BULLETIN NO. 2

Rocky Hill Intermediate School – Phase 2, Rocky Hill, CT

Rocky Hill Intermediate School Pre-Bid RFI Log – Bulletin 002
Updated: March 21, 2018

DRAWING NO.:
L2.01

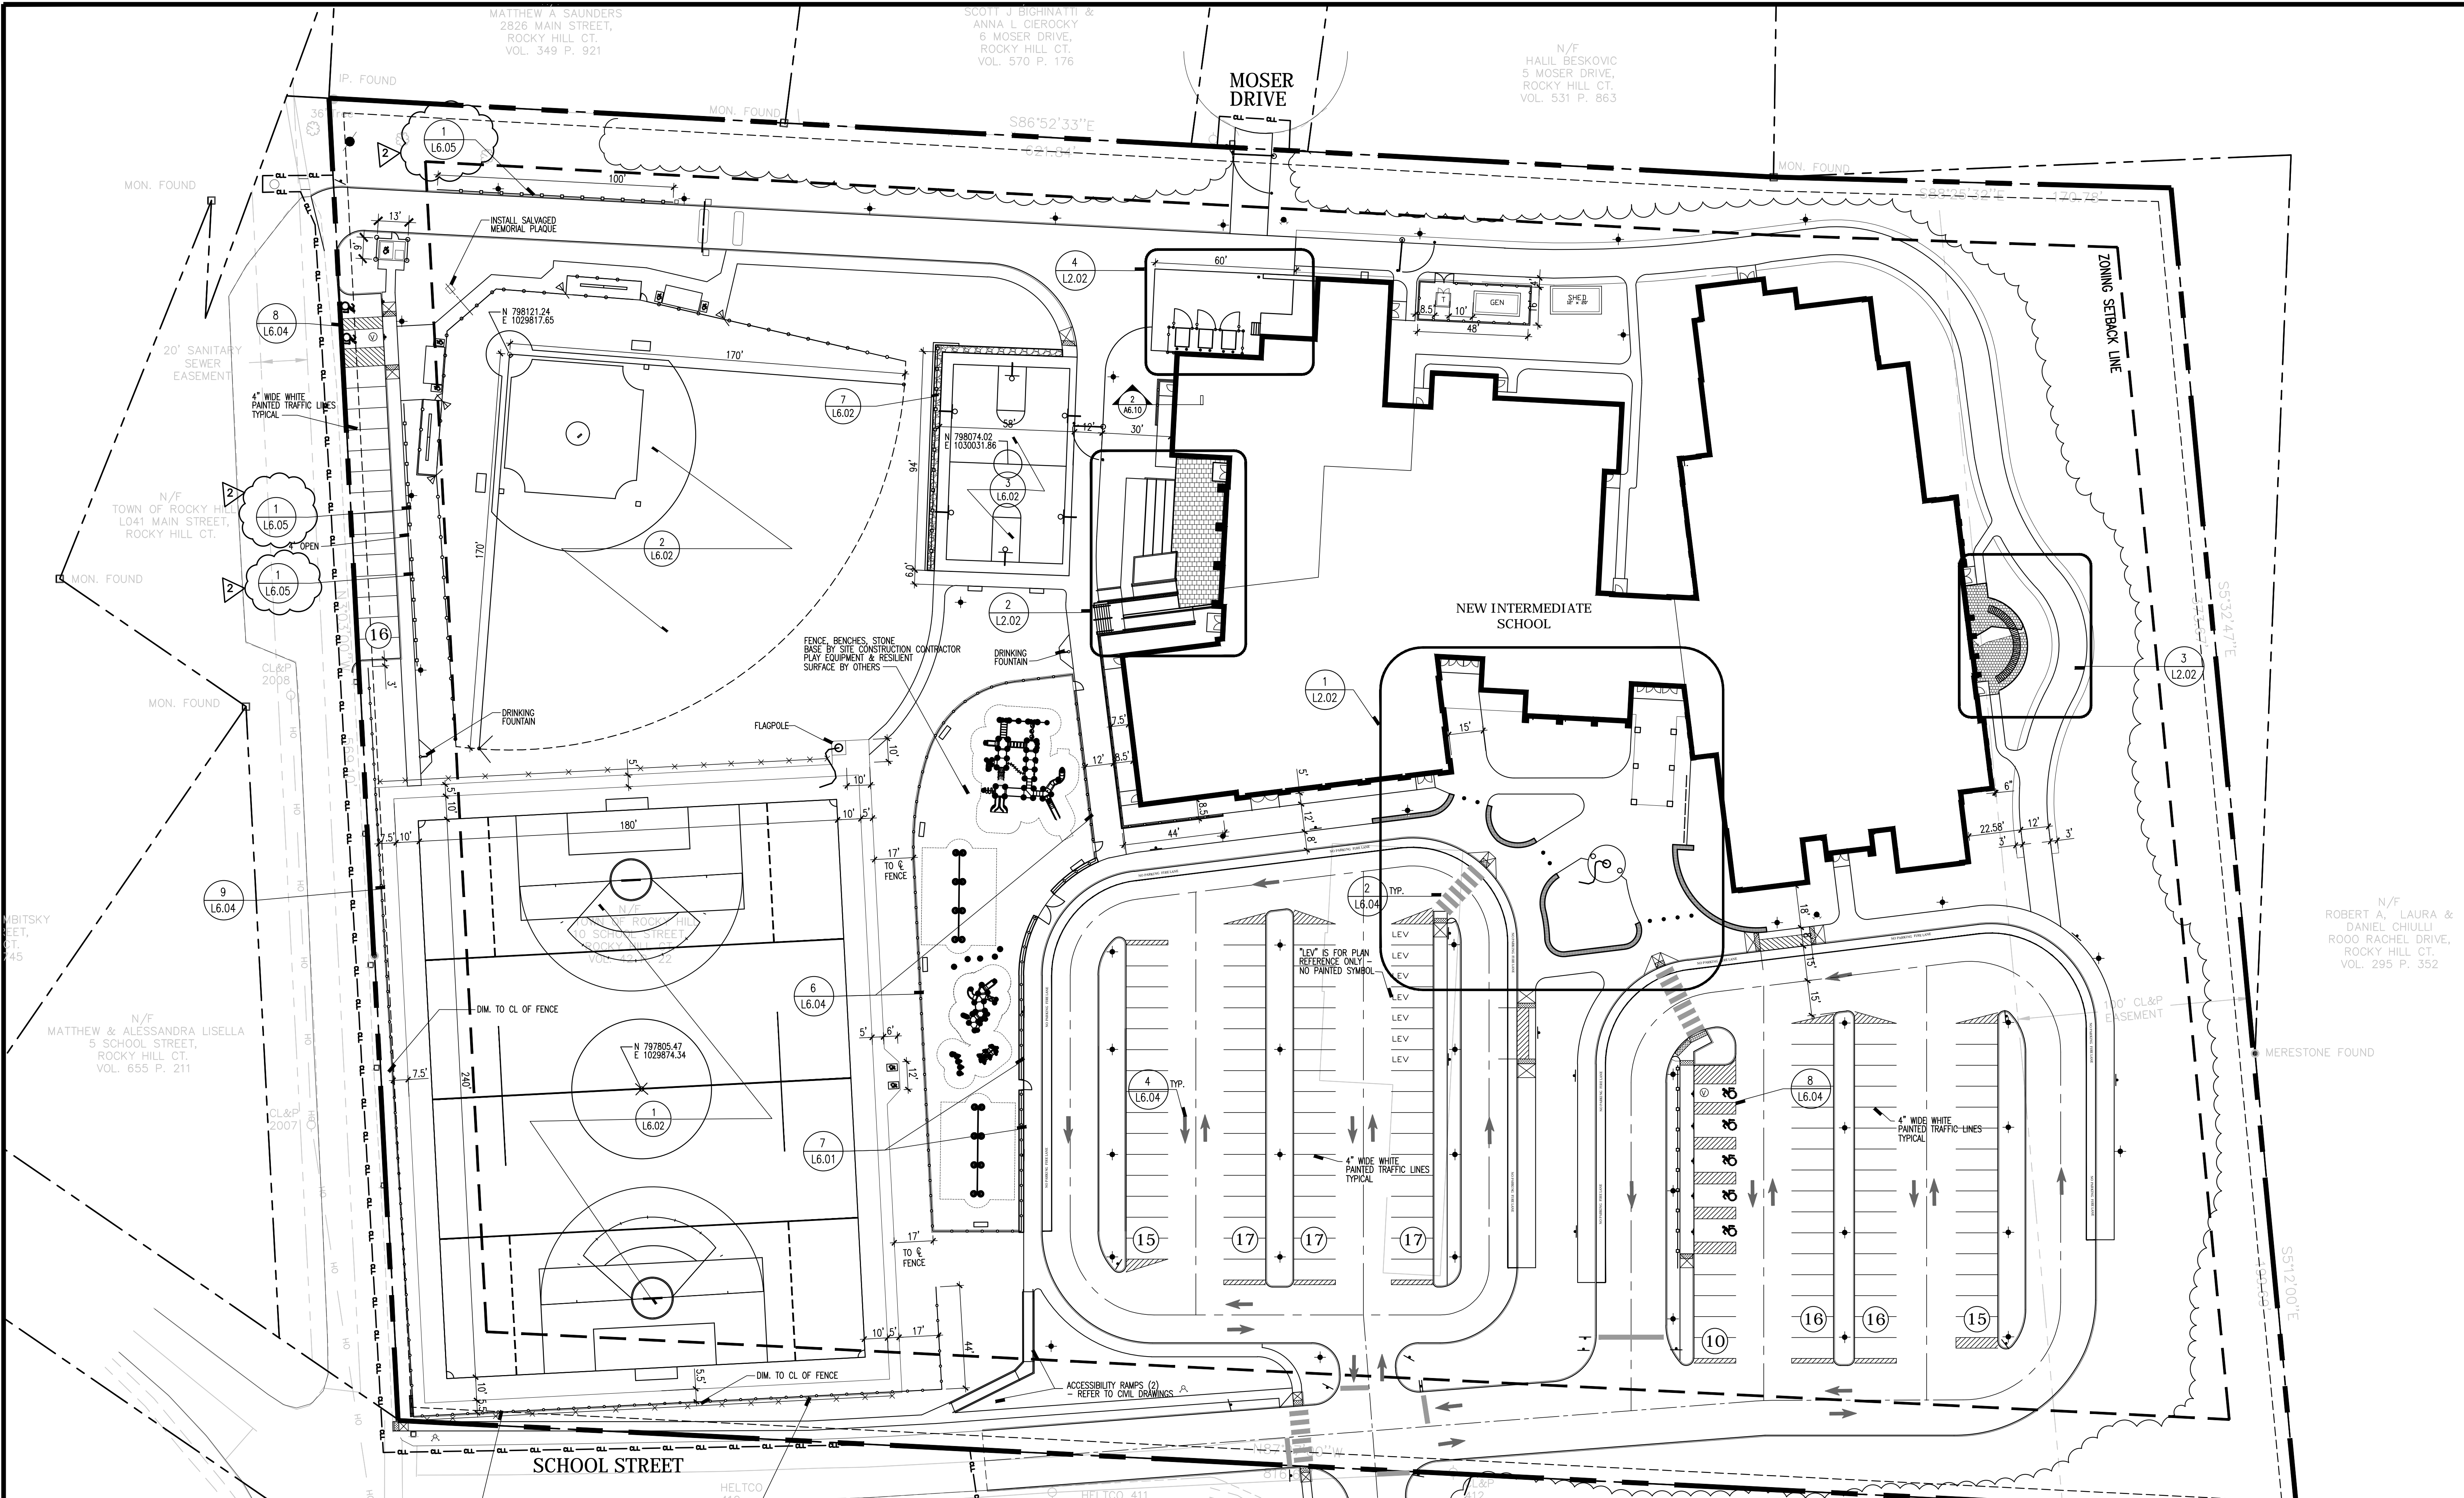
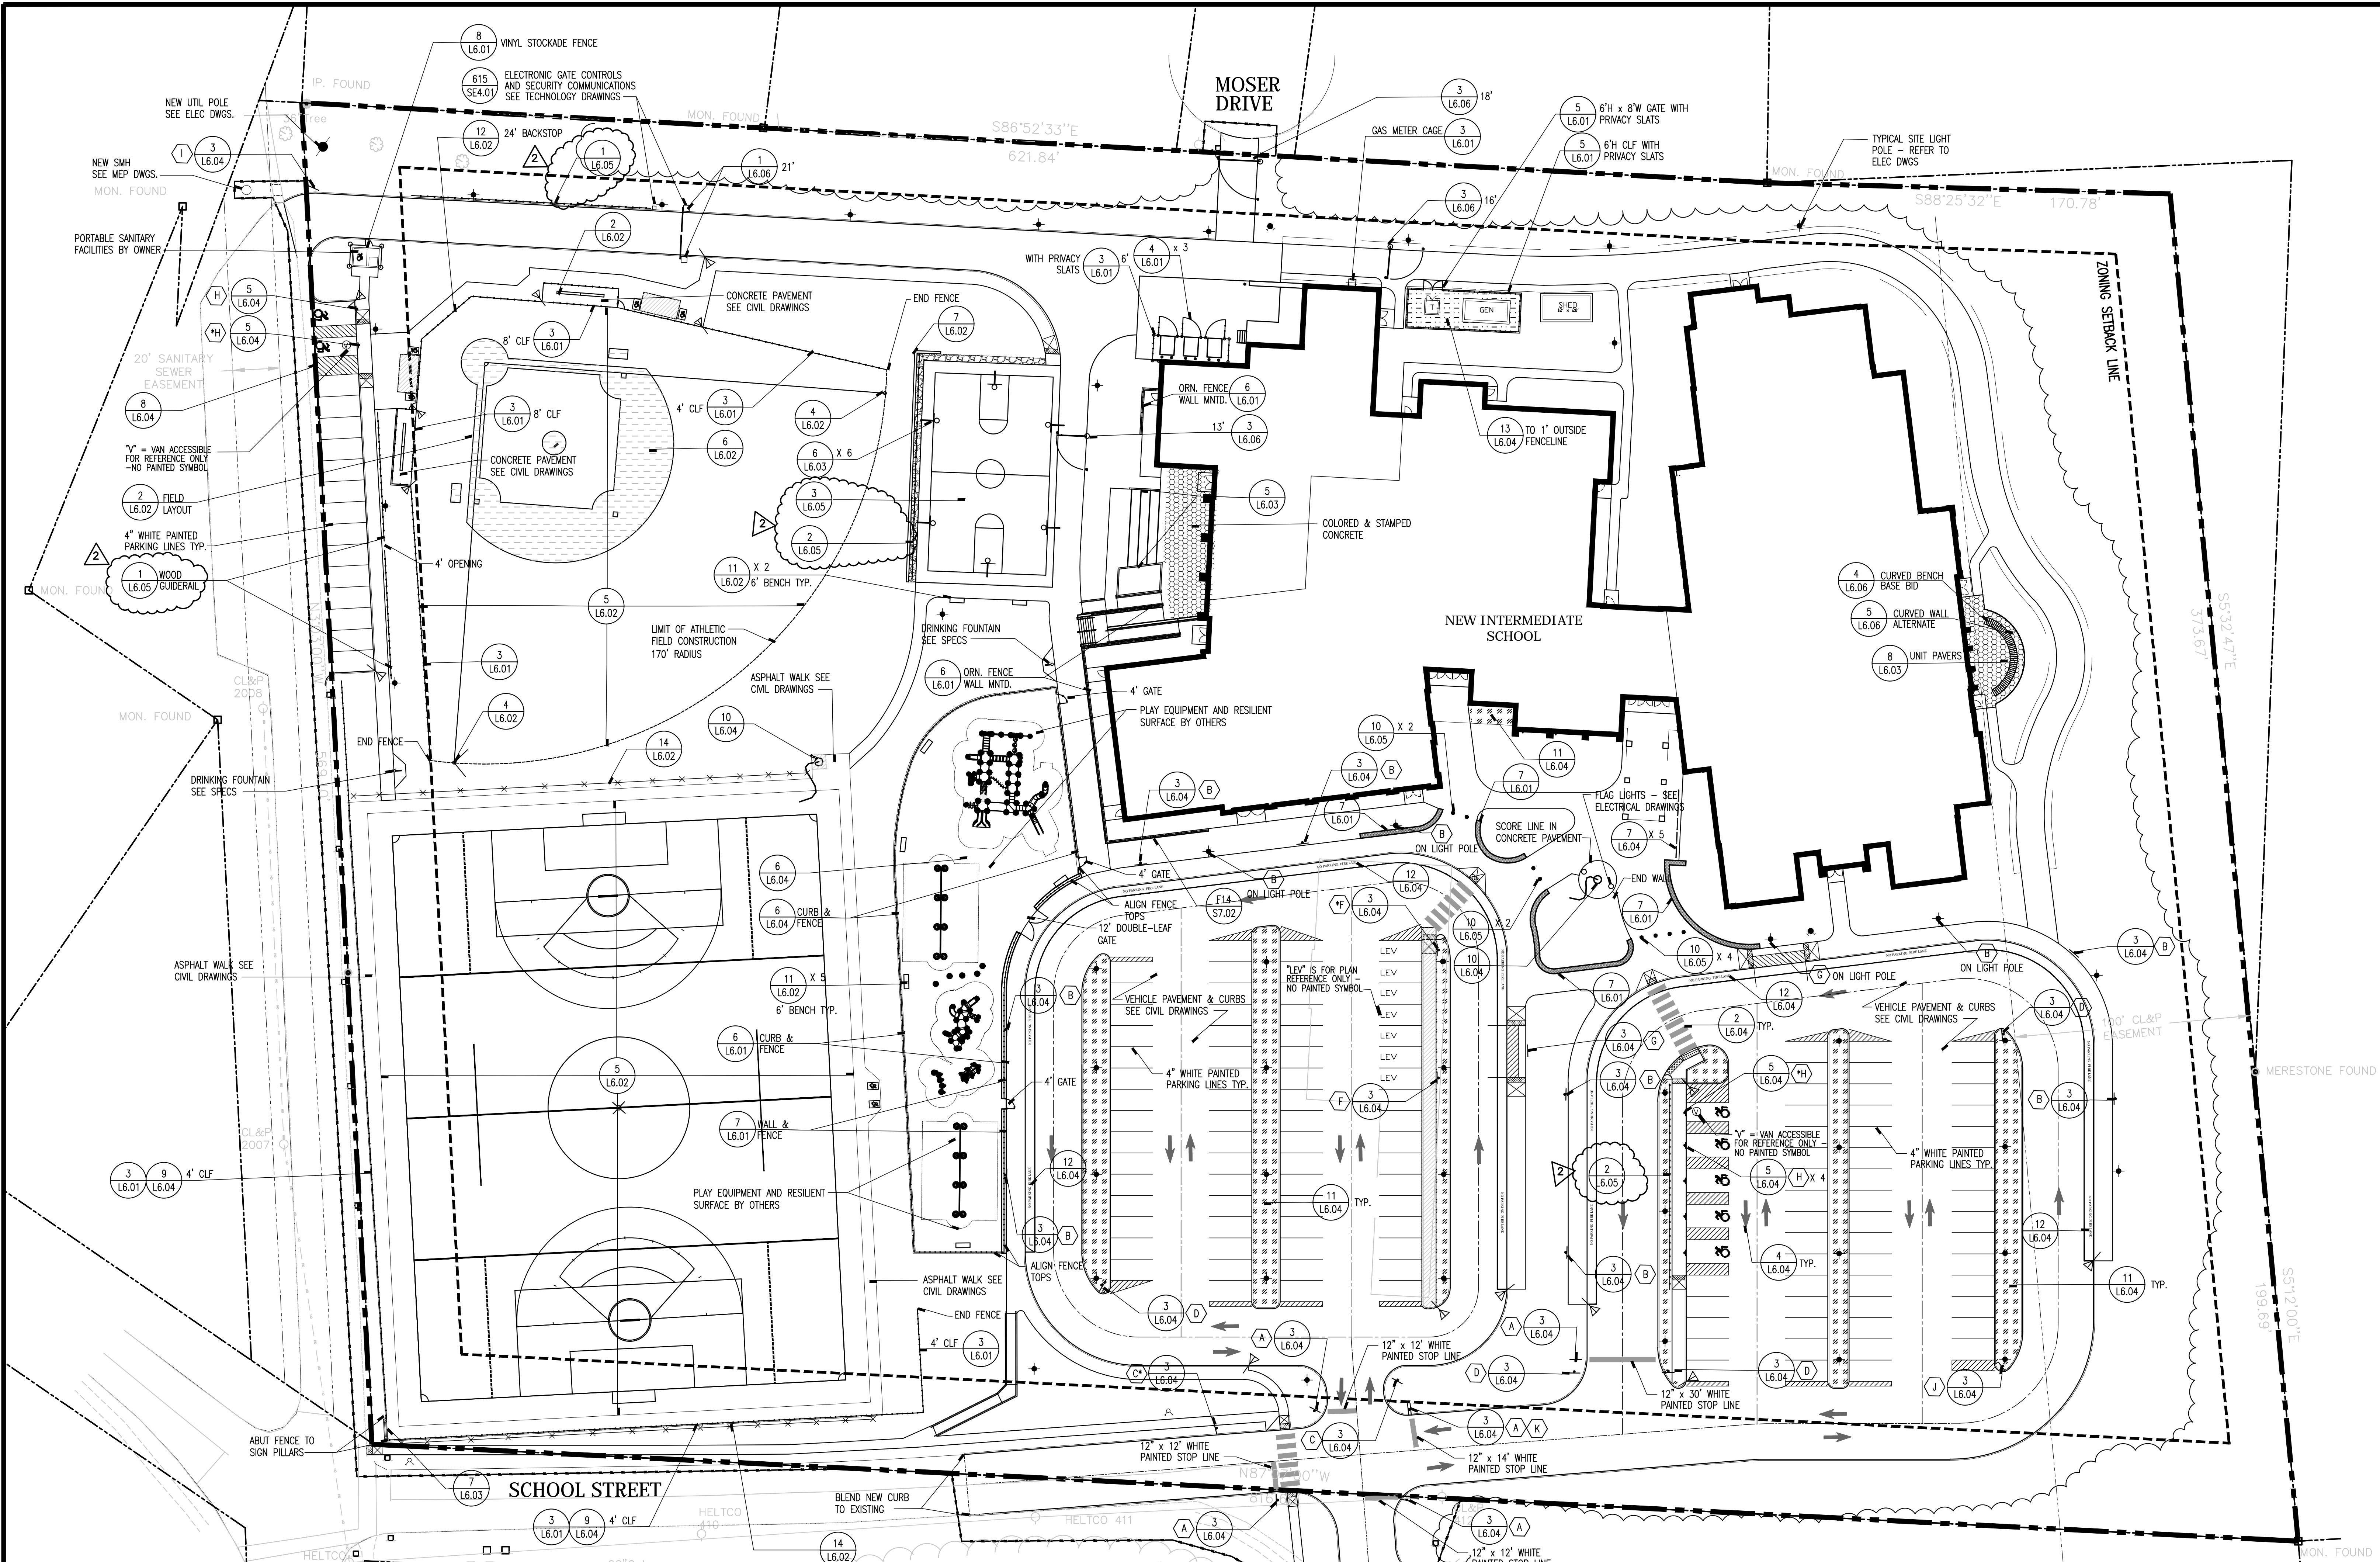
At guard rails north and west of the baseball field, change reference detail button to read: "1/L6.05".

DRAWING NO.:
L3.01

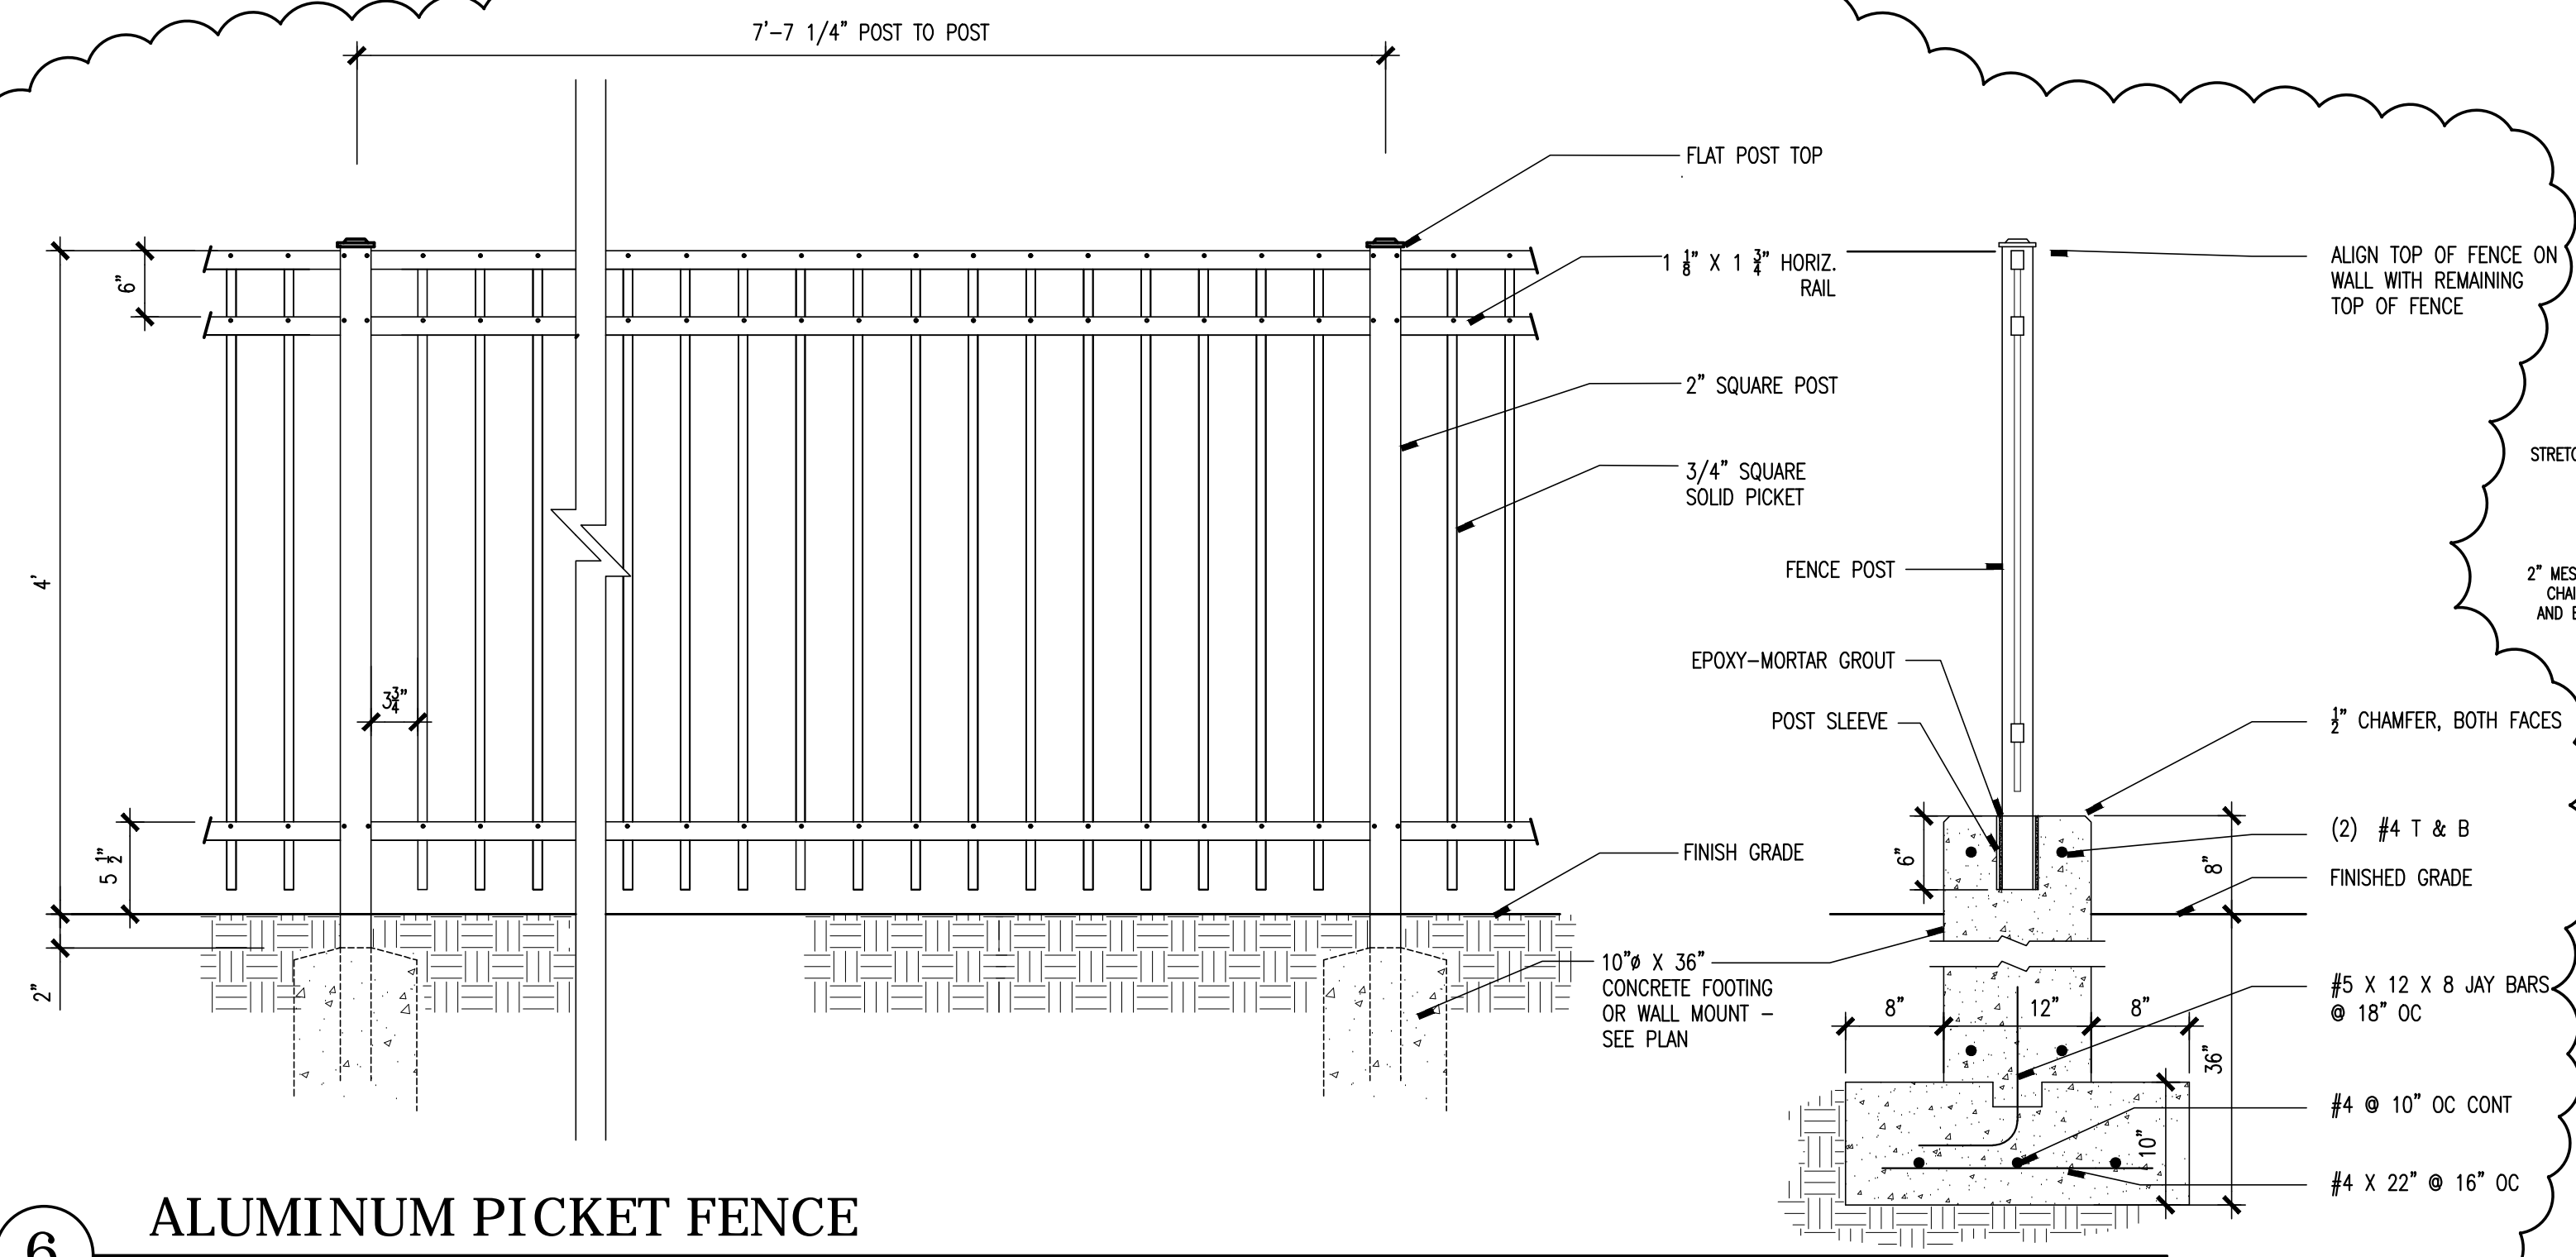
At guard rails north and west of baseball field, change detail reference buttons to read: "1/L6.05".

At basketball court, change guard rail reference detail button to read: "2/L6.05".

At Accessible Parking Spaces in front of school, change reference detail button to read: "2/L6.05".
